POTENTIAL FAILURE OF SBM TYPE SWITCHES

Subject: Report No: P21-01072015. Report of potential failure of GE Hitachi (GEH) SBM type Switches per 10CFR Part 21

Conical Spring Orientation

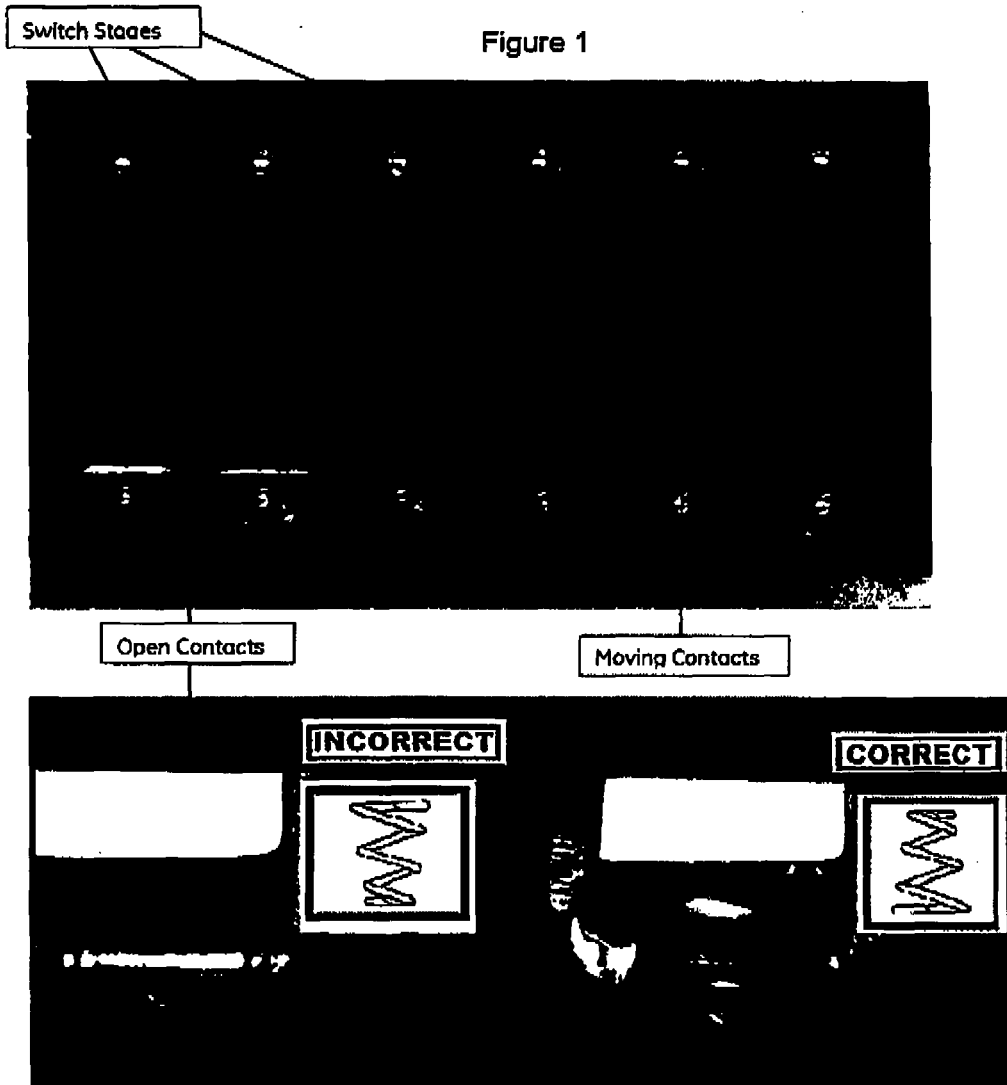
This condition has been reported in GEH document SC 14-19 (dated Dec. 11, 2014) in which GEH notified their affected licensees of the potential failure of SBM type switches, manufactured and shipped January 2012 through December 2014, due to incorrect installation of a conical spring (see Figure 1). AZZ|NLI procured and dedicated commercial grade SBM type switches, manufactured during this time-frame, and subsequently provided to:

The cause of the failure was incorrect installation of a conical spring, which subsequently shifted and resulted in the switch failure. GEH determined that SBM switches shipped in the period from January 2012 to December 2014 may have the subject condition.

NLI recommends that all identified GEH SBM type switches be inspected at the next available interval (as determined by the plant) to verify the spring orientation. Licensees may request further guidance from AZZ|NLI regarding inspection methodology.
